### ADDENDUM TWO

Project: Cleveland St. Streetscape Phase III & Festival Core

Date:	March 4, 2021
Project No.	<b>Cleveland Street Streetscape Phase III, 16-0003 EN &amp; 19-0026-EN</b>
To:	Catherine Corcoran, RLA
From:	Christina M. Newcomb, PE
Subject:	<b>RESPONSES TO CONTRACTOR'S QUESTIONS – PRE-BIDDING PHASE</b>

**A** TYPICAL CURB CUT & DRIVEWAY - PLAN  
353

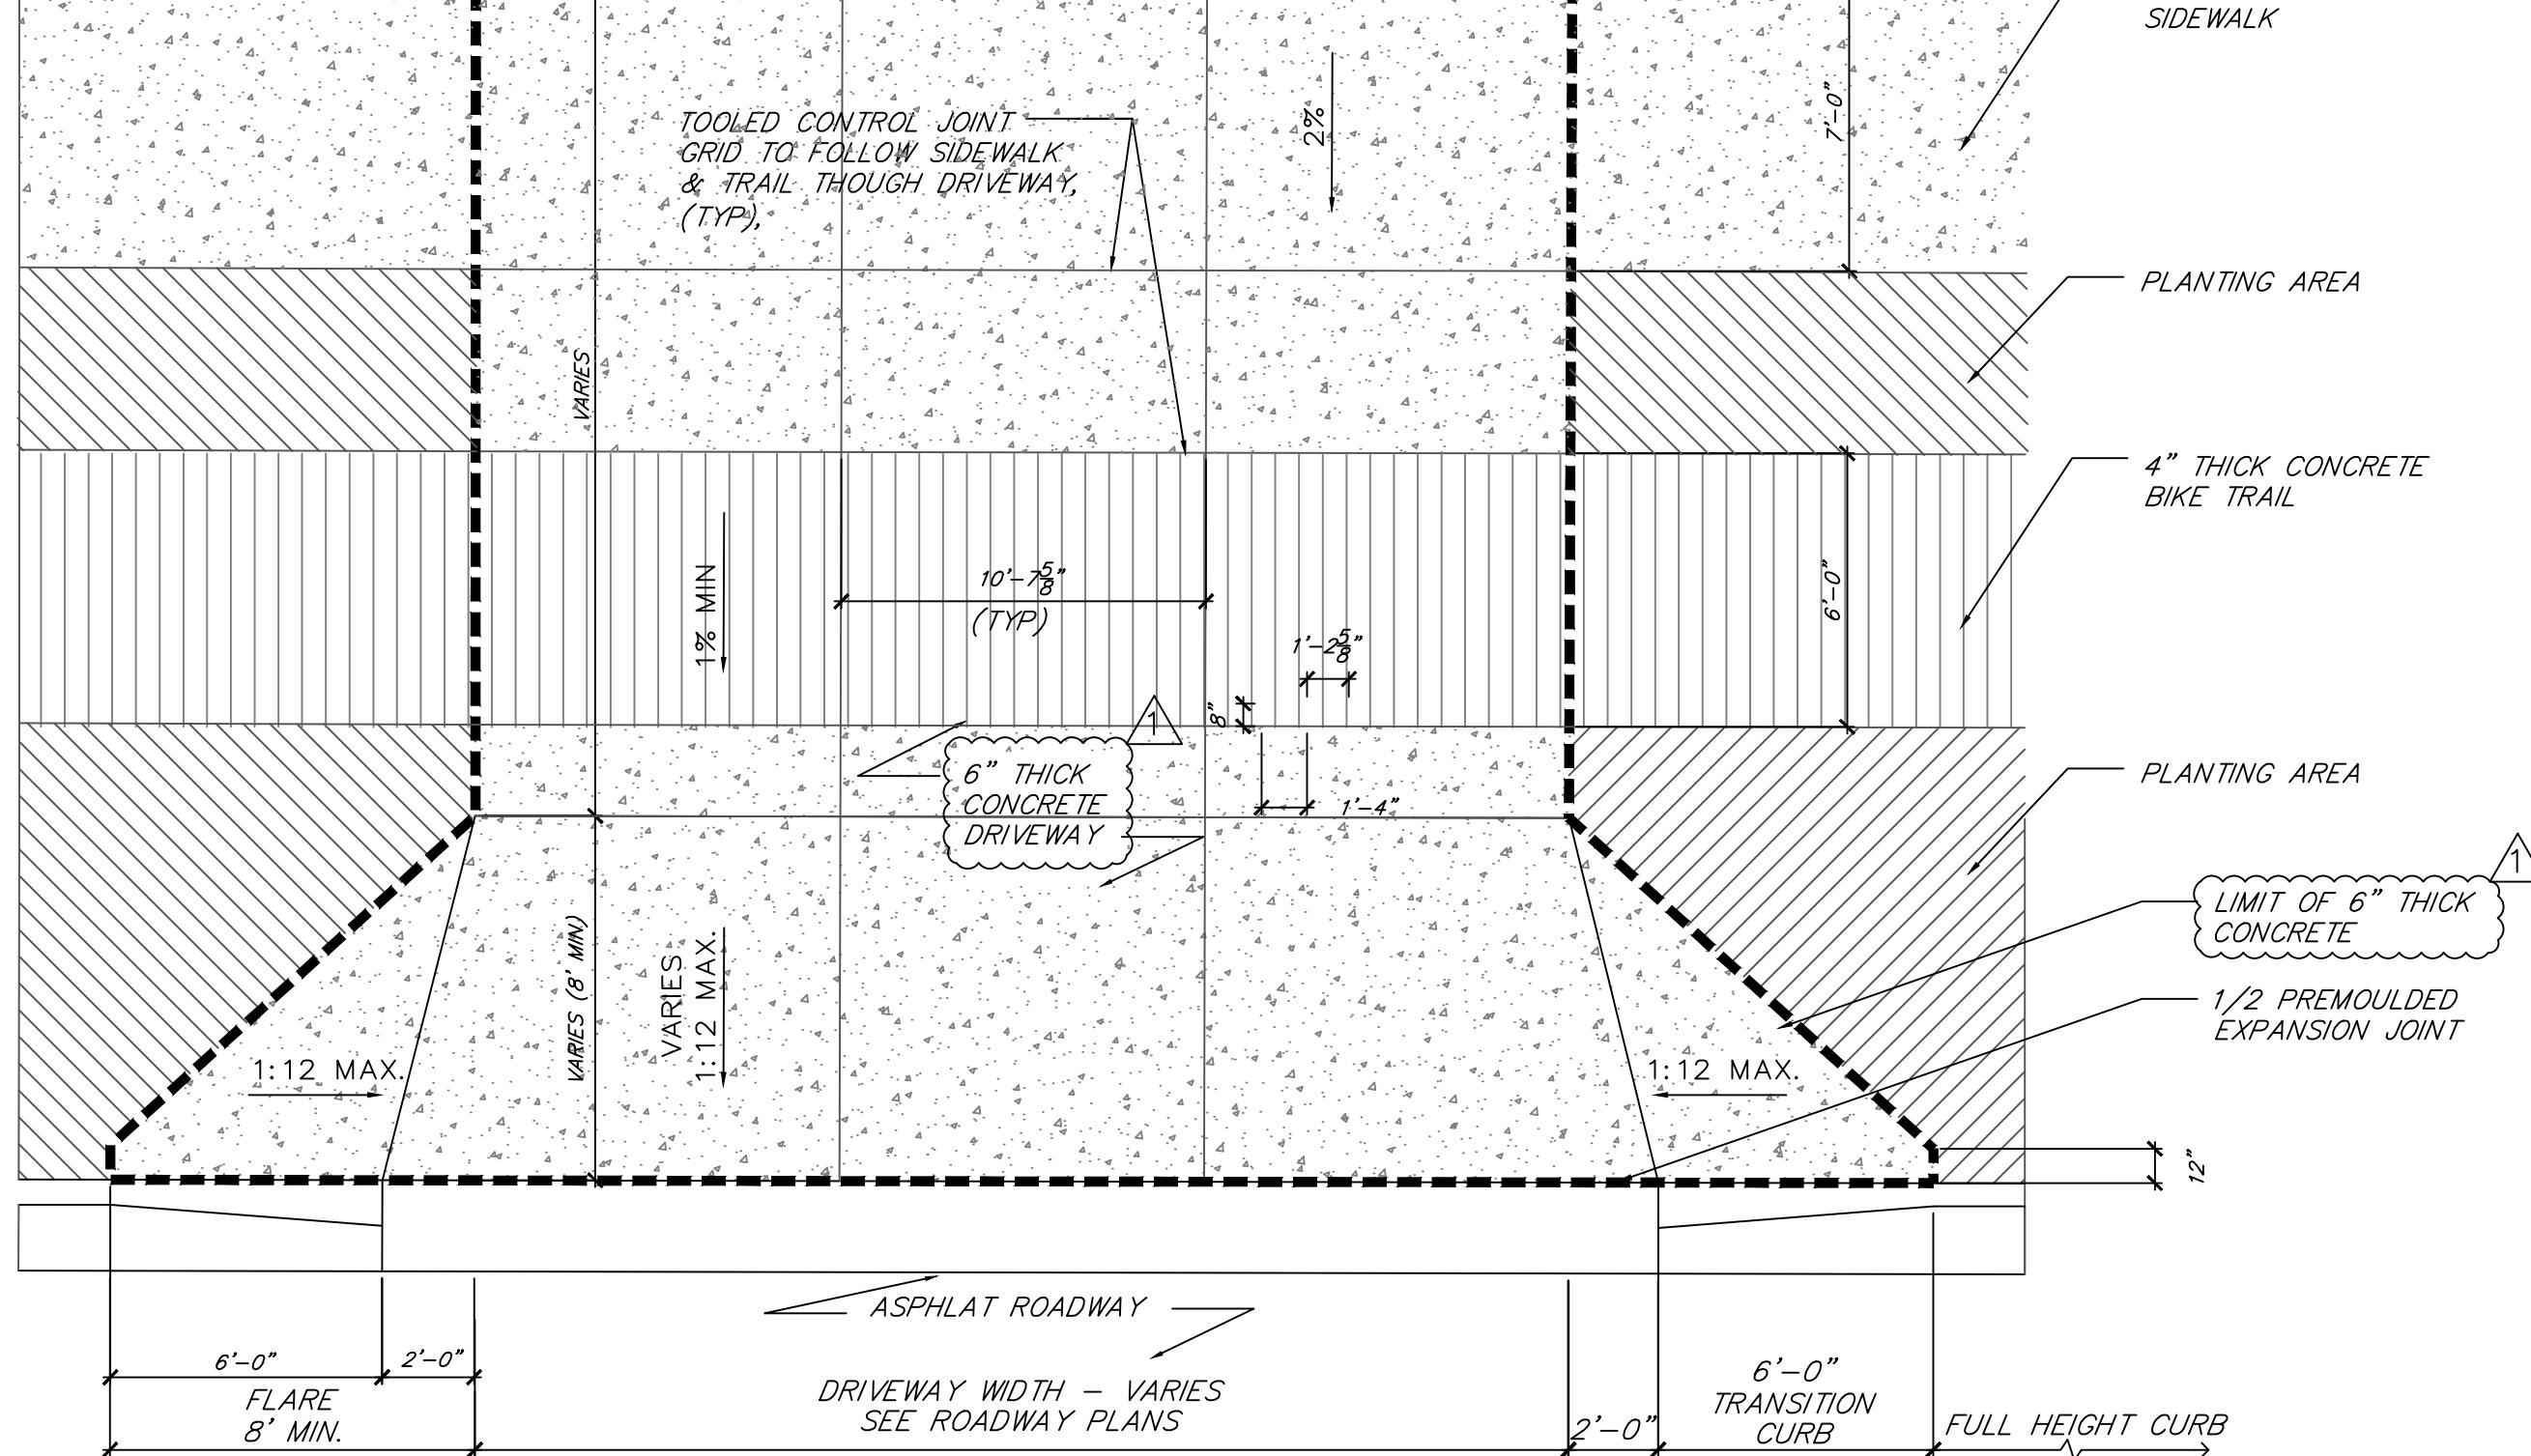
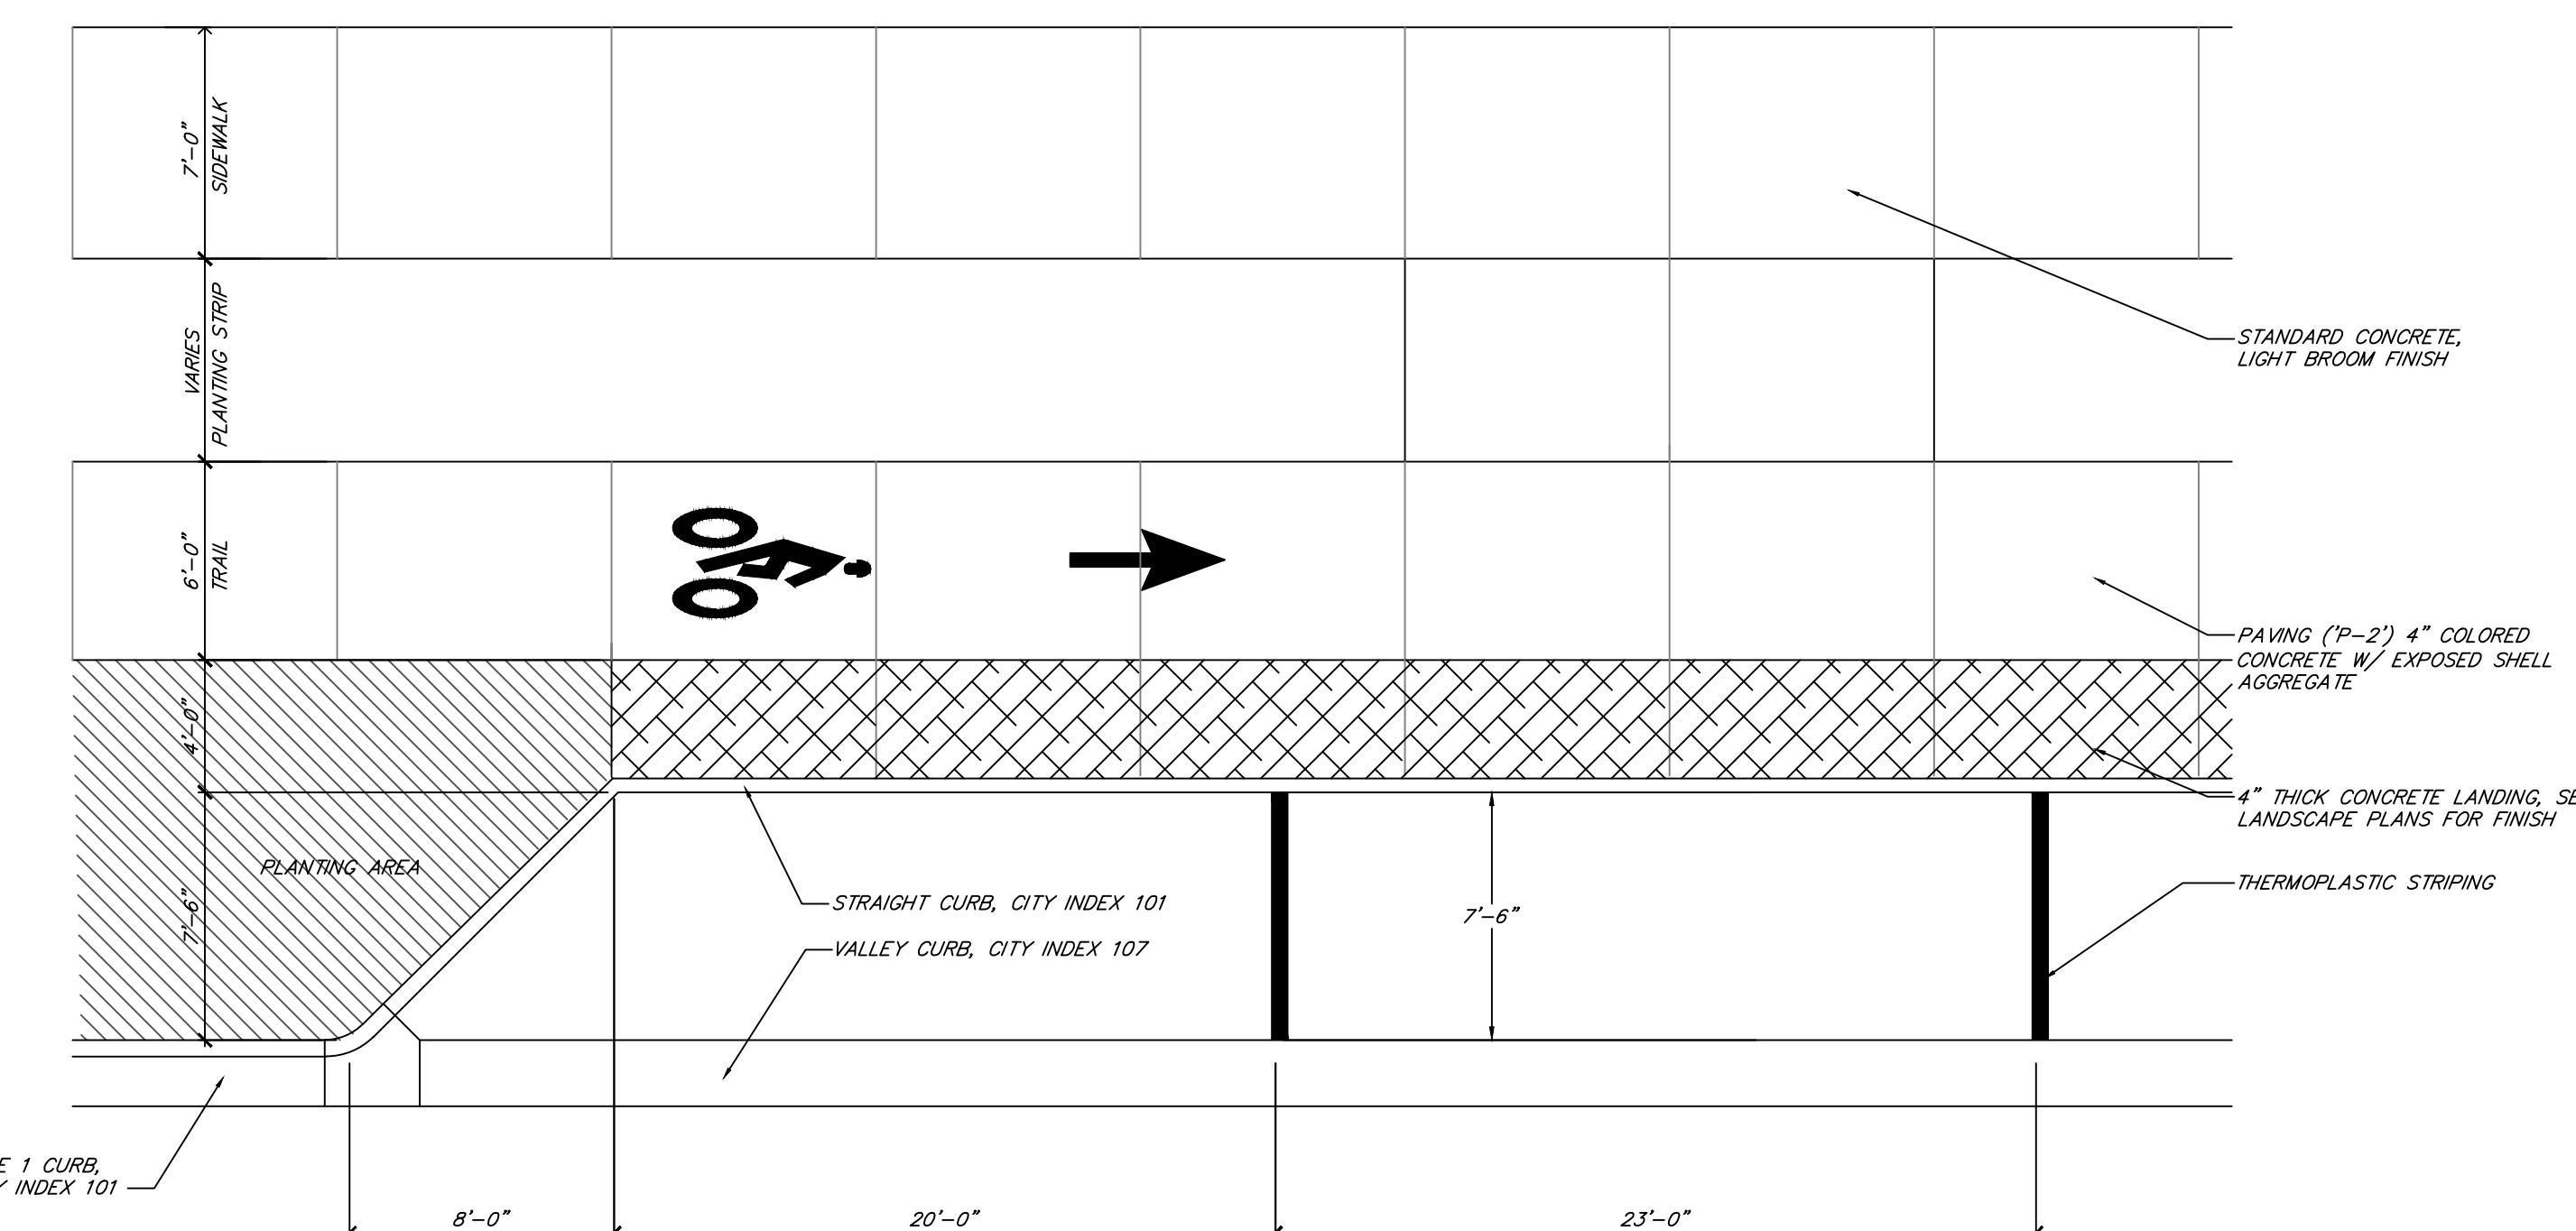
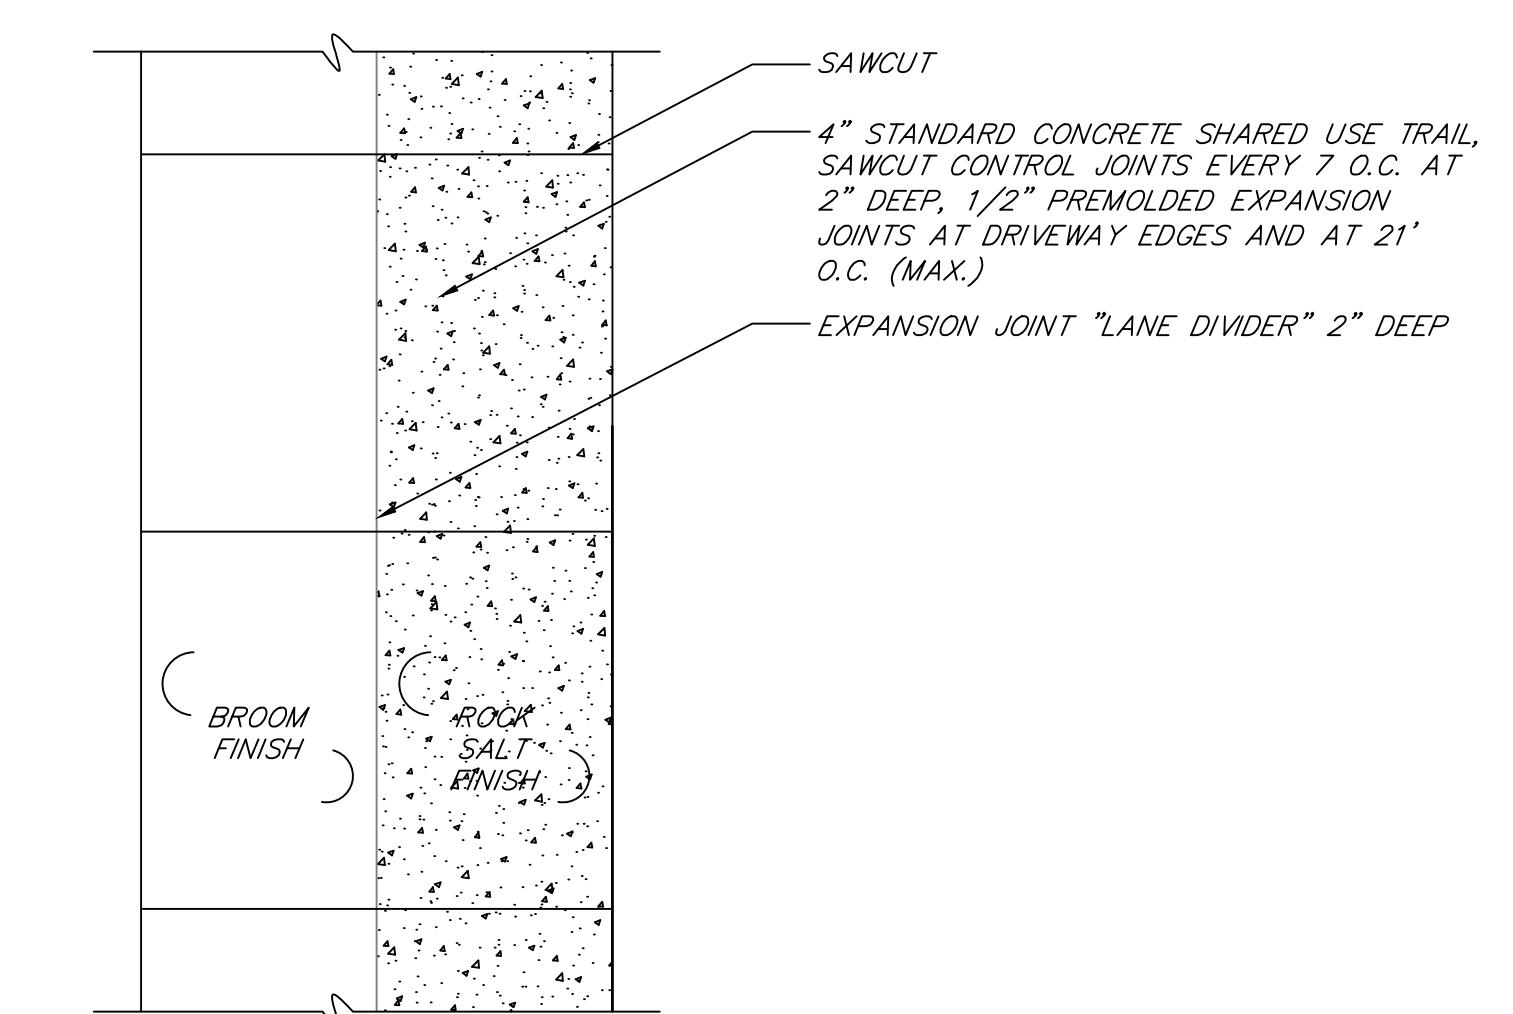
4. Drawing 354 is calling for 8" thick concrete driveway. Please provide a pay item and quantity for this work.

36. The Roadway plans call for all driveways to be 6" thick reinforced (typically). Detail A/354 indicates the driveway apron to be 8" thick, along with 4" thick bike trail and 4" thick sidewalk. Please clarify what thickness and finishes are used through the driveways.

***Update Response on website: The callout for 8" driveway on the detail is a typo (plans will be updated). All Driveways shall be 6" thick, within the limits shown on the detail. All sidewalk pavement and bike lanes shall be 4" thick, per the detail. Separate Pay Items will be added, the Pay items will be updated with the thicknesses.***

**Response: The driveways are to be 6" thick. Detail will be corrected.**
